**Development Review Committee
Staff Report
May 17, 2017**

Case No:	17MINORPLAT1027
Project Name:	Ballinger Minor Plat
Location:	8405 Dawson Hill Road
Owner(s):	Martin F. III & Melissa Ballinger
Applicant:	Martin F. III & Melissa Ballinger
Representative(s):	Al Matherly
Project Area/Size:	32.80720 Acres
Jurisdiction:	Louisville Metro
Council District:	20 – Stuart Benson
Case Manager:	Zach Schwager, Associate Planner

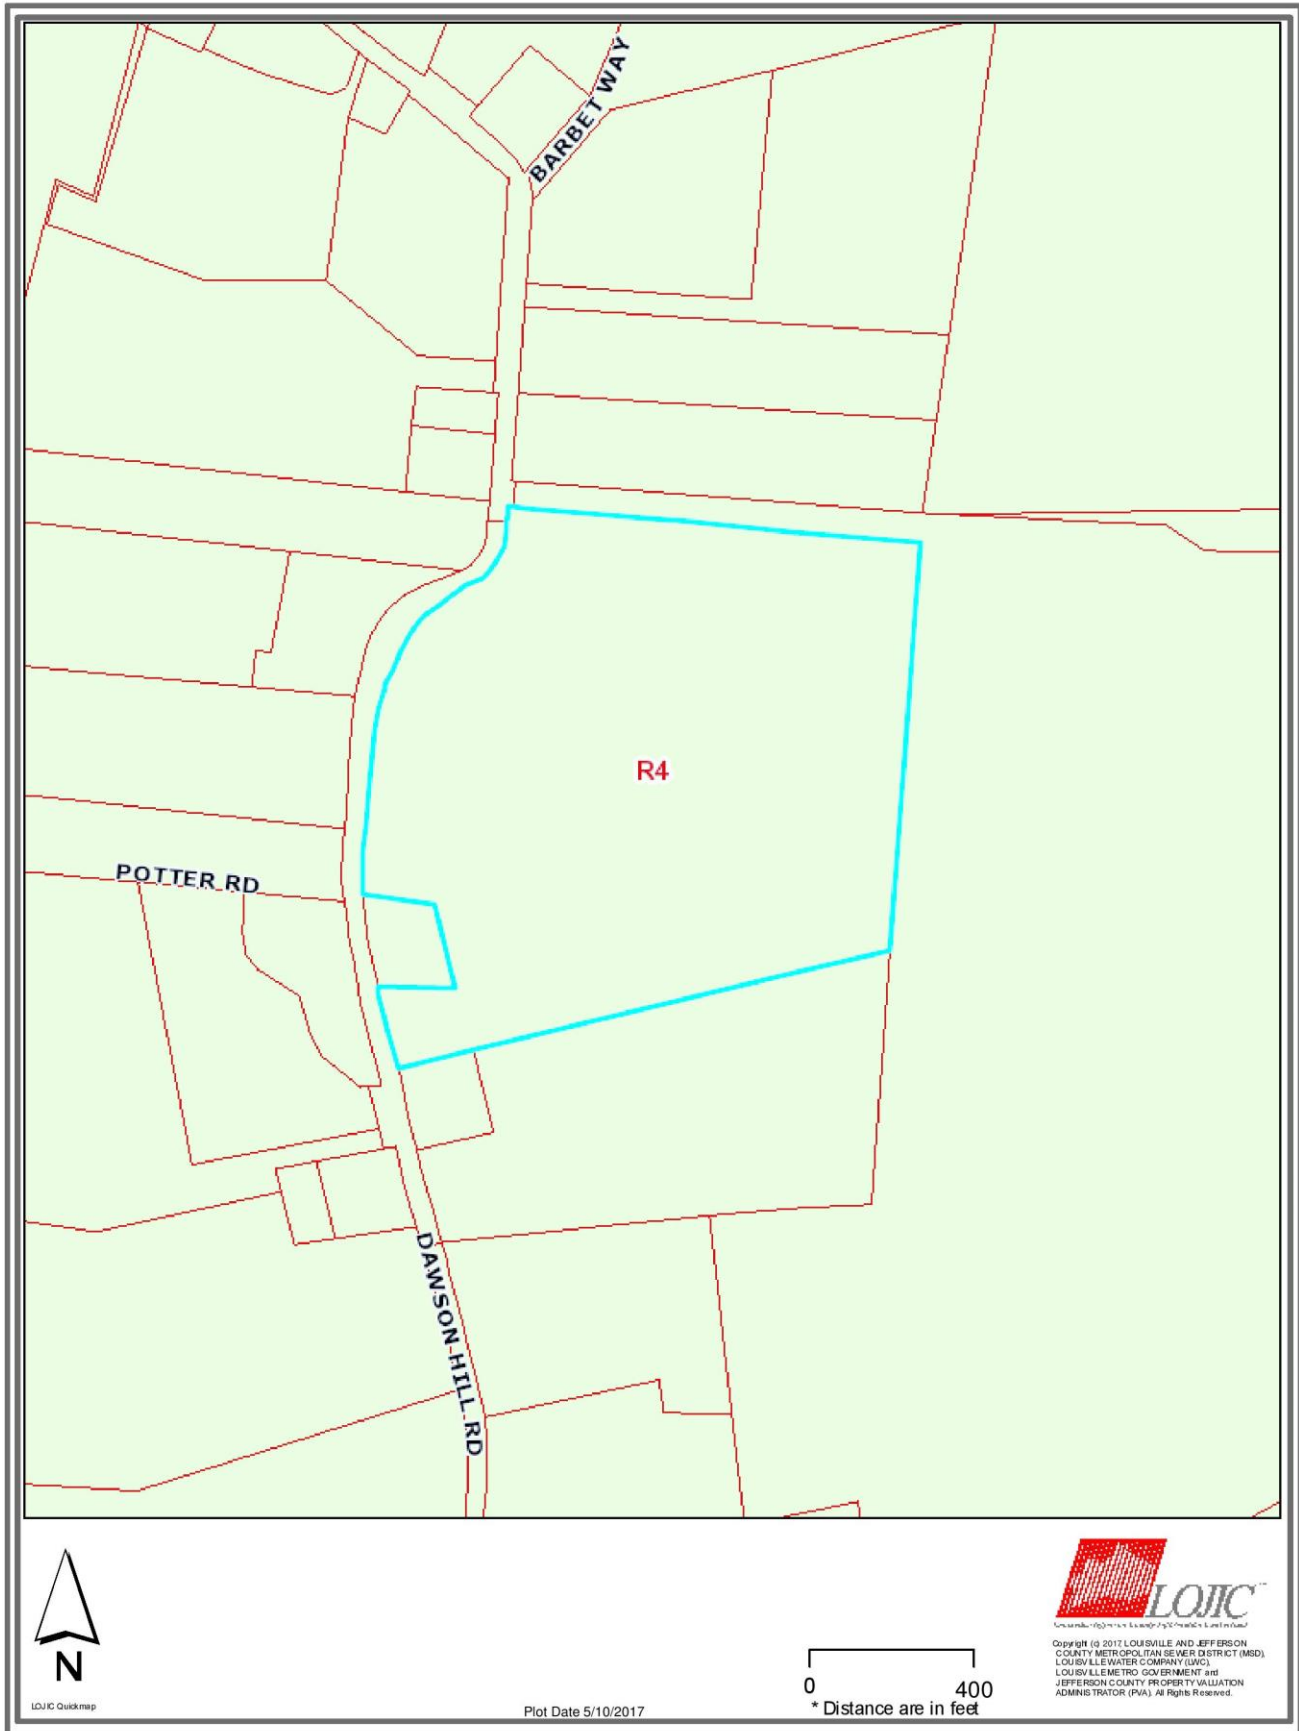
STAFF: The extent of the waiver of the regulation is the minimum necessary to afford relief to the applicant as the existing driveway serving Tracts 1, 2, and 4 is along the northern part of the property and the terrain to the south leading to Tract 3 has a pond, a stream, and hilly topography making it difficult to navigate. Allowing individual direct single-family access to Tract 3 is the minimum necessary waiver to allow the owner/applicant reasonable use of 10.018 acres of land.

There are two ponds and two USGS Intermittent streams on site, which would be impacted by the minor subdivision if a shared driveway easement were proposed. Transportation Planning has not stamped the plat yet as they are requiring a site inspection for the existing gravel driveway. The gravel driveway is currently 10' in width and per LDC 6.2.1.A, 7.8.12.E & LMCO #90-2004 the gravel driveway must be 12' in width. The plat

shows 12' for the width of the driveway as that is what will be approved, but this will need to be field verified by Transportation Planning.
